MEMORANDUM FOR: Bernard J. Snyder, Director
TMI Program Office

SUBJECT: MEETING BETWEEN BNL AND GPU REGARDING WASTE
SOLIDIFICATION

Subject Spent Resin Liner Dewatering Study

TMI UNIT II
SPENT RESIN LINER
DEWATERING STUDY

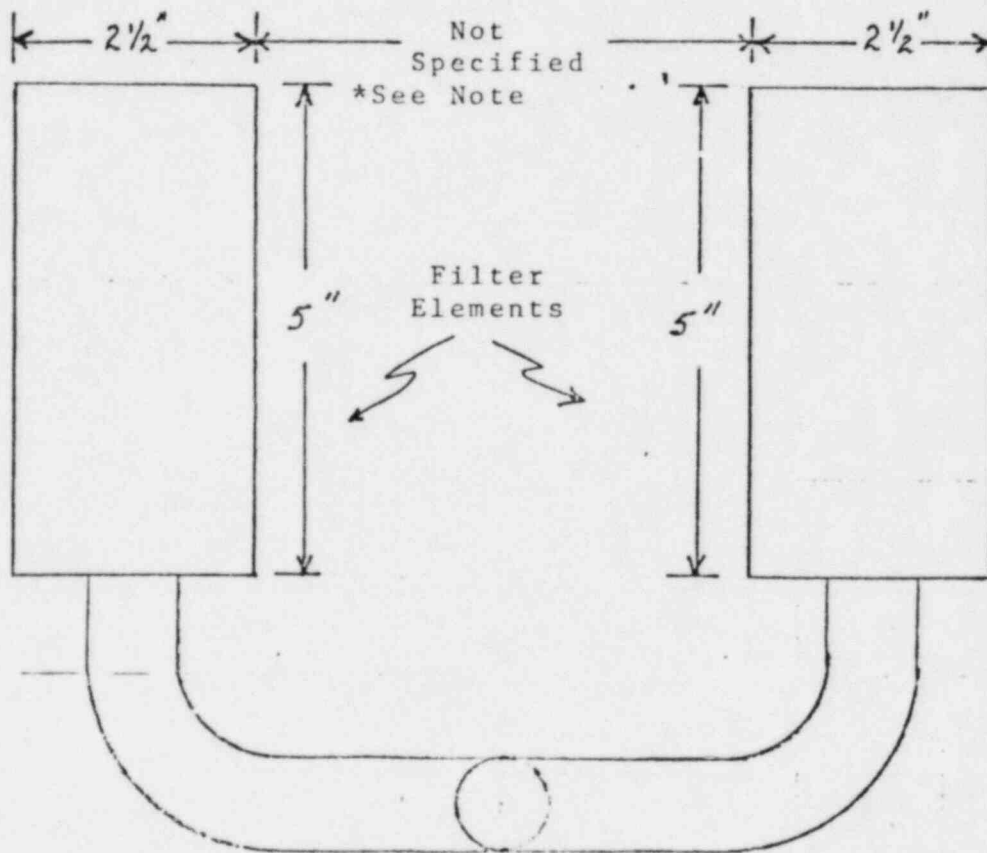
Their component test did not meet 0.5% remaining water requirement (see clipped pages). Nevertheless, they have proceeded with liner dewatering test. ~~The~~ Cap-Gum is performing these tests at site and we will followup (Tim Johnson is reviewing this report also). This report is a progress report on dewatering test and intended for ^{my} keep us informed.

how you ever say
"all water"
I doubt it.

failed
